**SAN ANTONIO WATER SYSTEM**  
**Interdepartment Correspondence Sheet**

**Subject:** Zoning Case Z2017142 (Ride Away Bikes)

**Date:** July 12, 2017

ZONING FILE: RIDE AWAY BIKES (FIGURE 1)

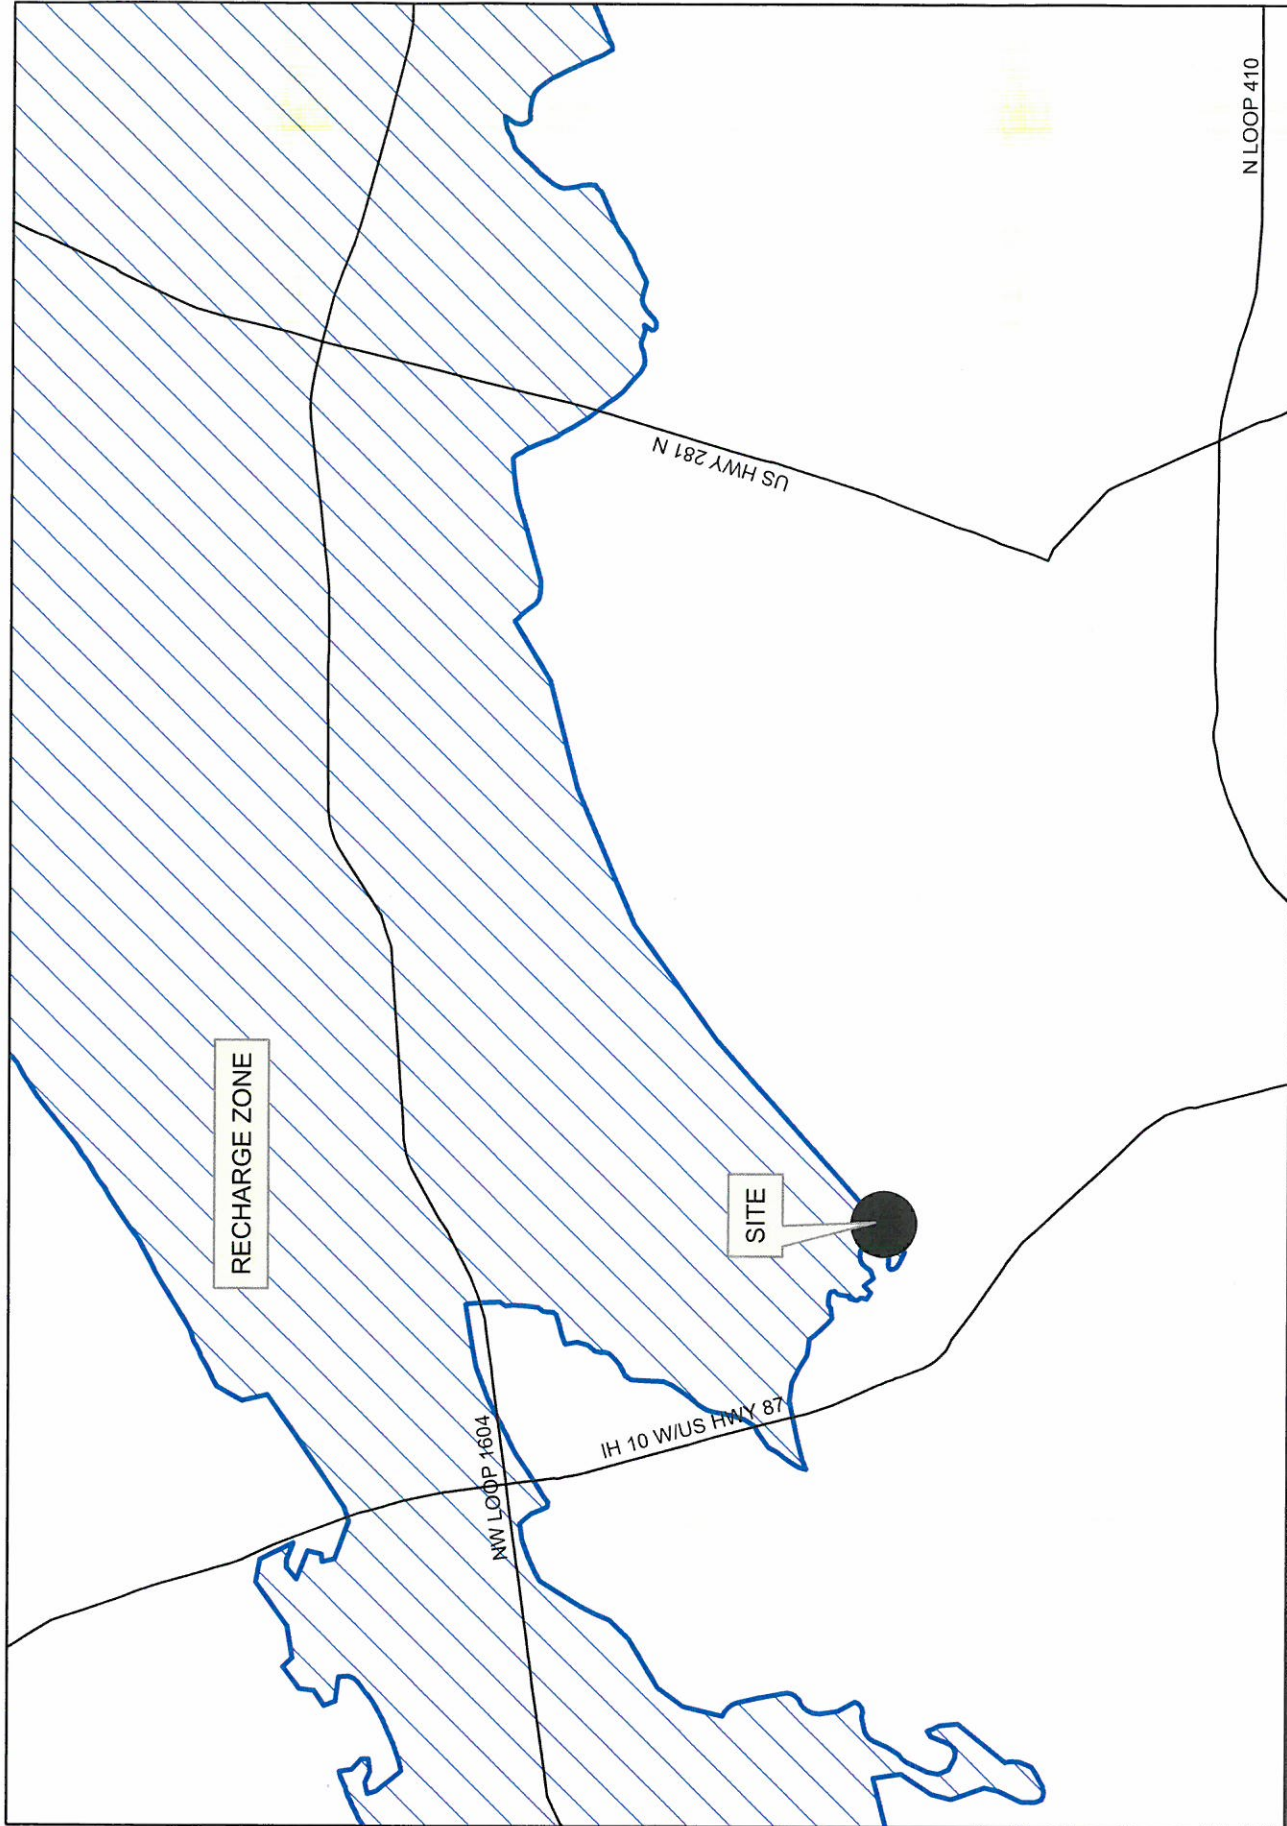
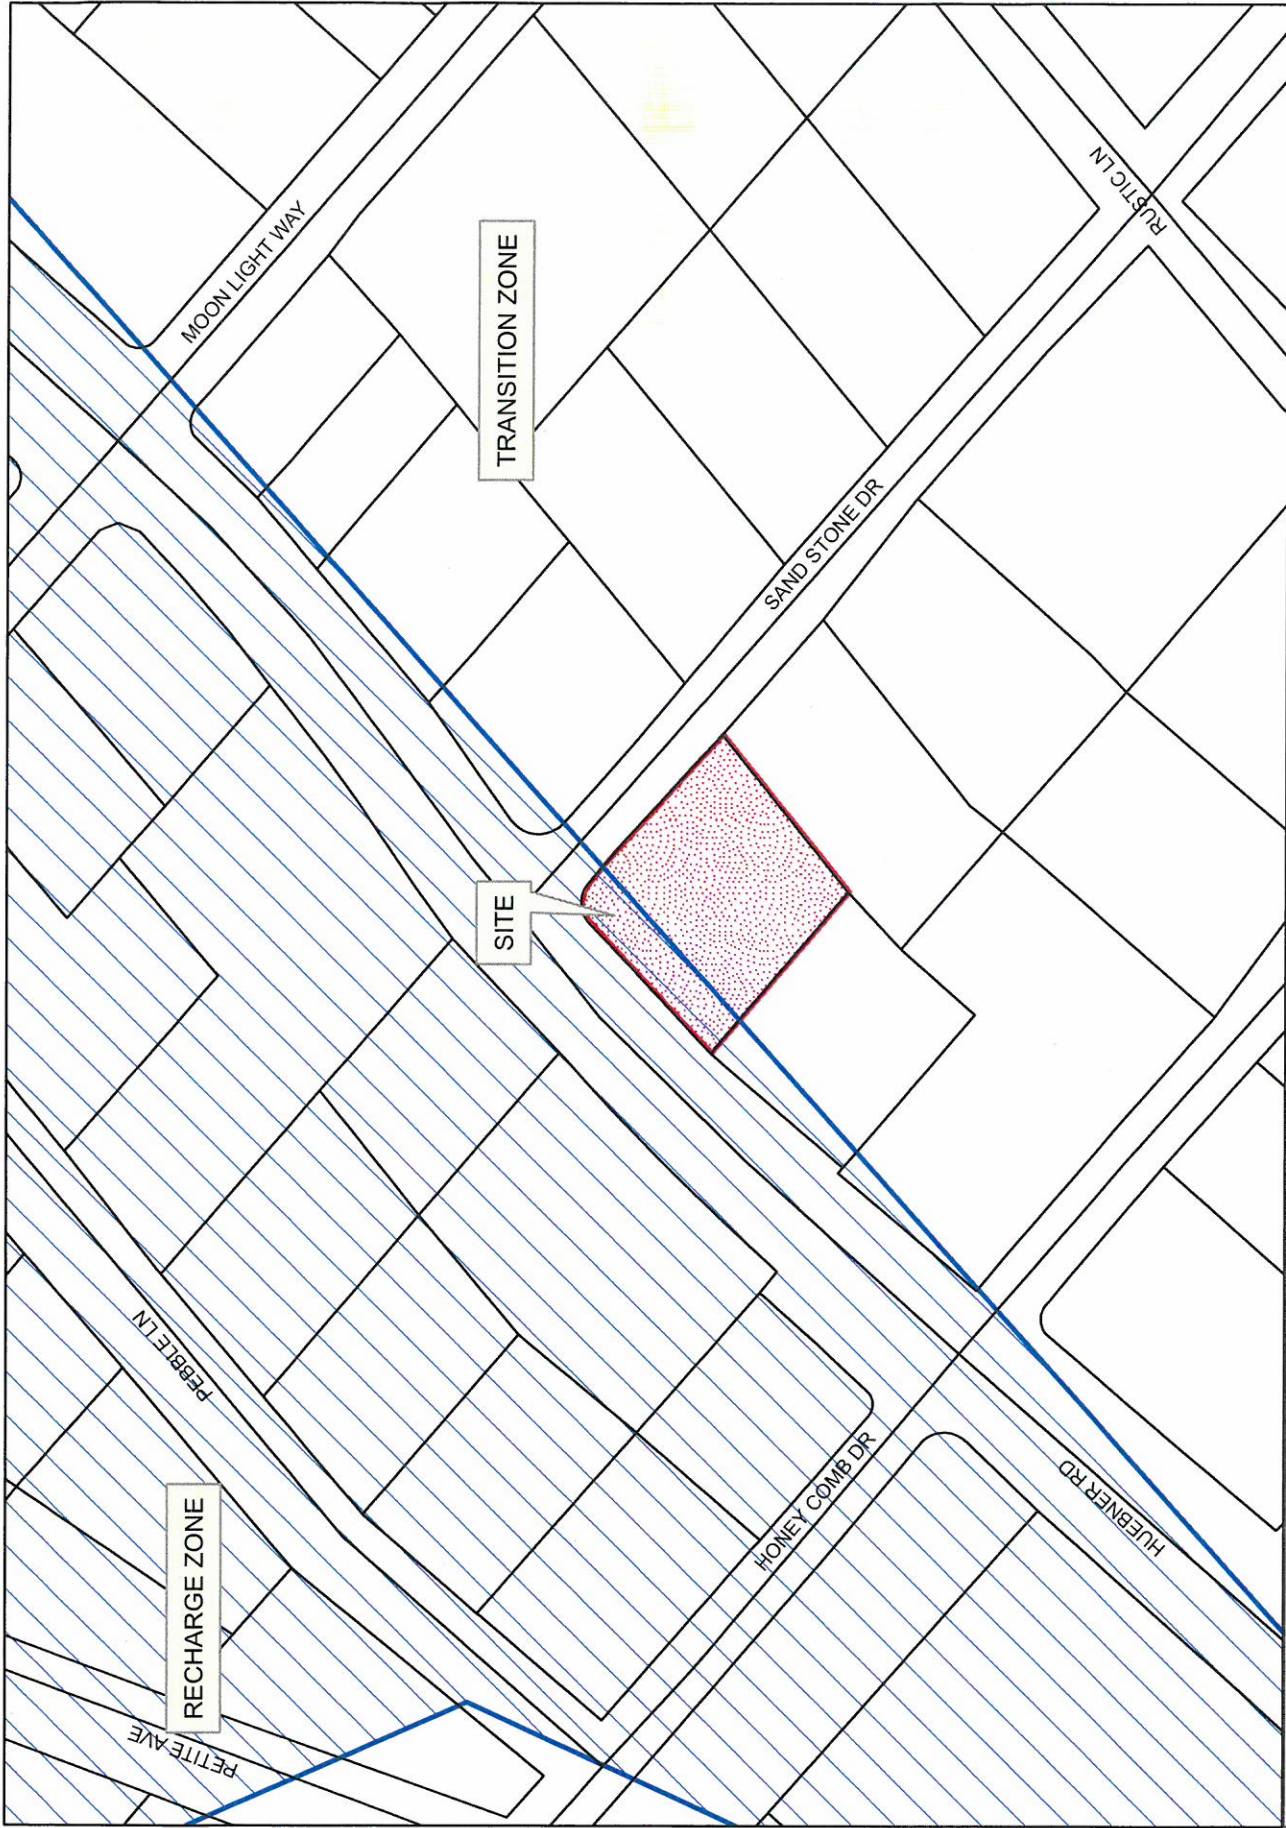
The subject property is located in City Council District 8, southwest corner of Huebner Road and Sandstone Drive. A portion of the property, 0.10 acre lies within the Edwards Aquifer Recharge Zone (Figures 1 and 2).

1. The impervious cover for the 0.10 acres located on the Recharge Zone shall not exceed 30% on the site.
2. The land uses within the project site shall be in conformance with the table of permitted uses at the time the re-zoning is approved. Should a proposed use be listed as requiring City Council approval, the owner/operator shall apply for re-zoning for that particular use at the project site. If the land use is listed as special use, a special permit must be obtained for that use. If the land use is listed as not allowed, that land use will not be permitted on the project site.
